Re: Plot No.13. A.M.2.
Artillery Maidan.

With reference to your letter No.
B.S.P. 309/35 dated 5th. June 1935, we have
the honour to state that :-

PLAN
SHOWING PROPOSED BUILDING
ON PLOT NO. 13. SHEET NO. A.M. 2.
ARTILLERY MALDAN
SCALE 8 TO 1.

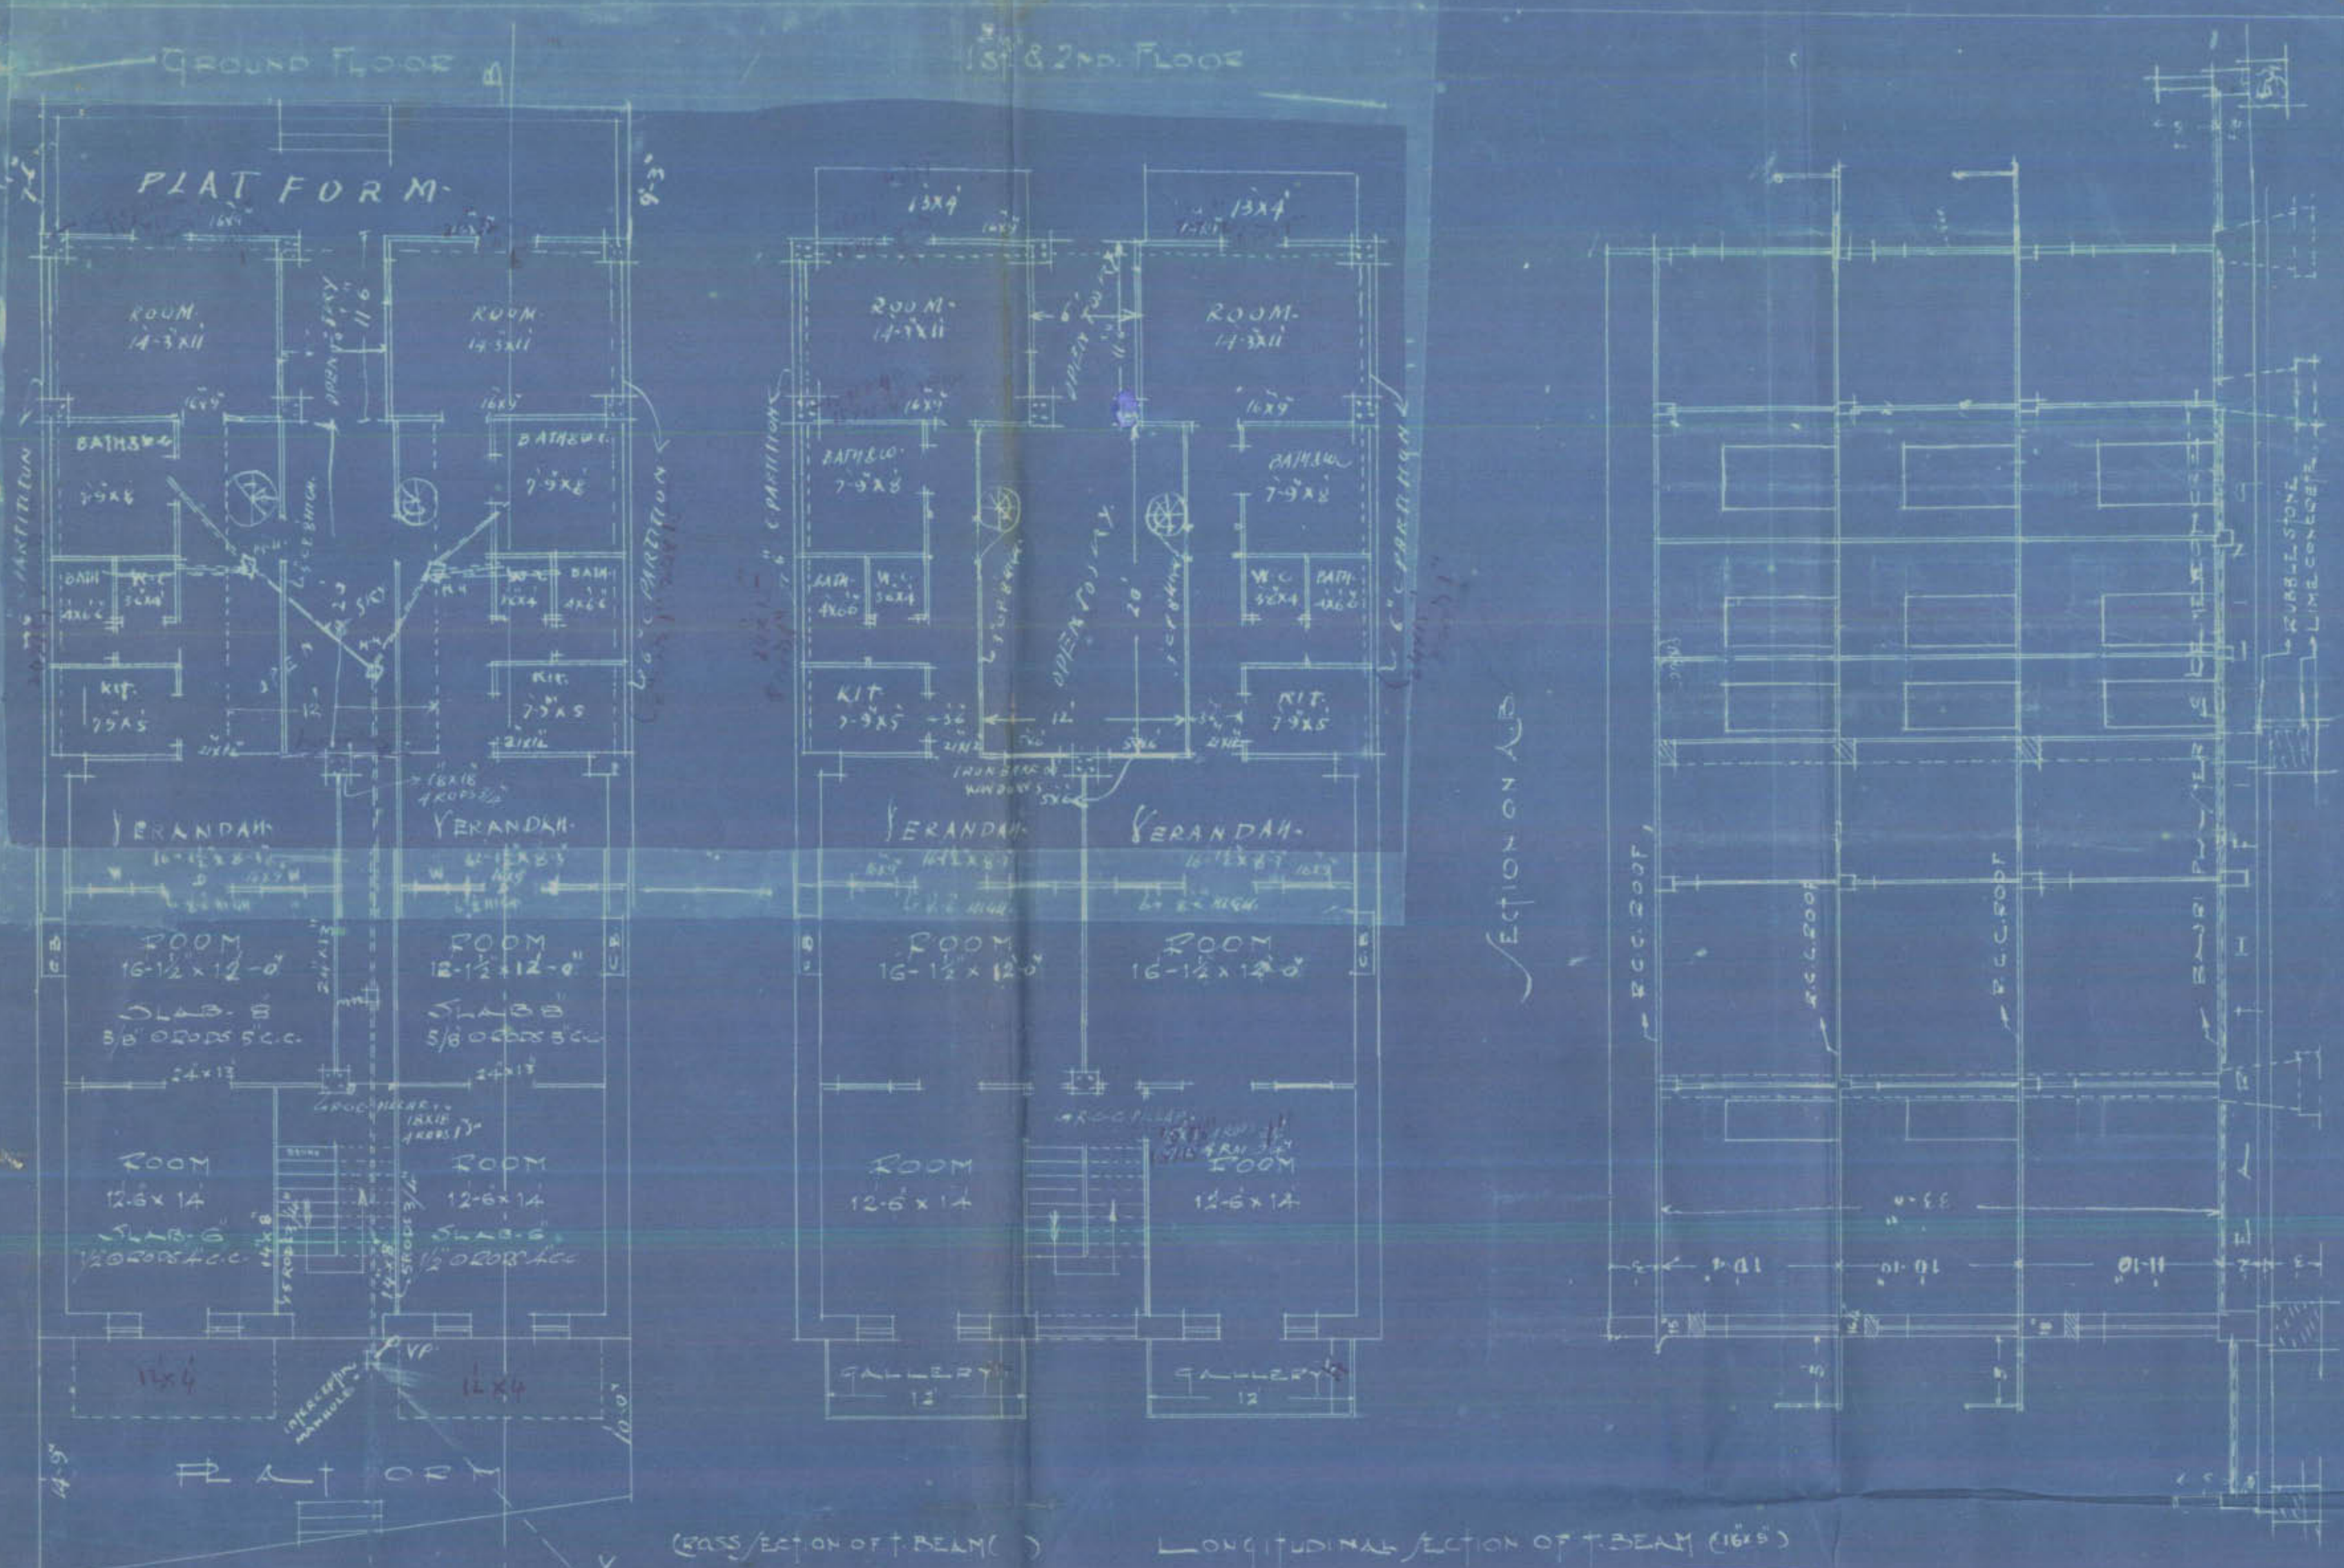
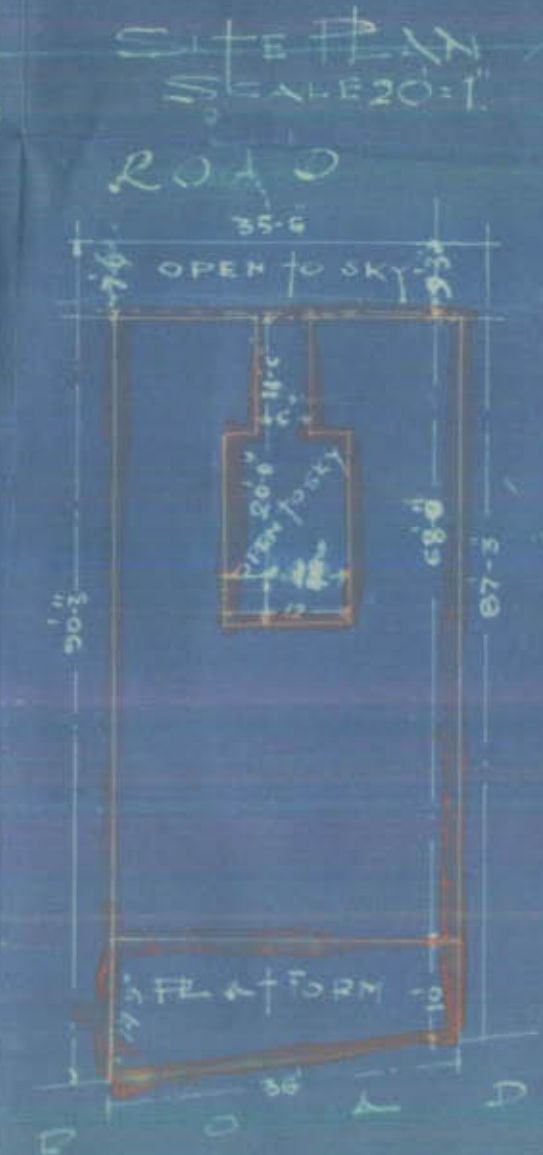
1. Rooms without verandah cannot be permitted.
2. Central room will be dark.
3. Instances may please be quoted from the locality where balconies have been allowed in 7½ and 10' compulsory open spaces.

✓ 4. Details of R.C. pillars, beams, lintels, slab etc be given with full dimensions & reinforcement.

- (1) — The H.O. has now removed this.
- (2) — The architect's reply be please perused and orders passed.
- (3) — The architect quotes instances — P&T No 1 AM 2 and 35 RB 11 belonging to the same owner.
- (4) — The details have been written down in ink by the architect.

(1) Vacant 16' $\frac{11}{2}$ " x 8' have been
~~complied with~~ provided.(2) Re: the Central room, the breadth
of the Internal open space has
been kept as per New Byelaws,
also the openings in the back vacated
have been sufficiently provided.
Besides the above, the height
of the partition between the central
room & the back vacated

3. But some have been permitted
 7 1/2' of this compulsory for
 spec in plots Nos 1 A. M. &
 35 the B. 11. There is no restriction
 in the conditions of sale & these plots require
 such permission
4. Objection No: 4 has been
 complied with.
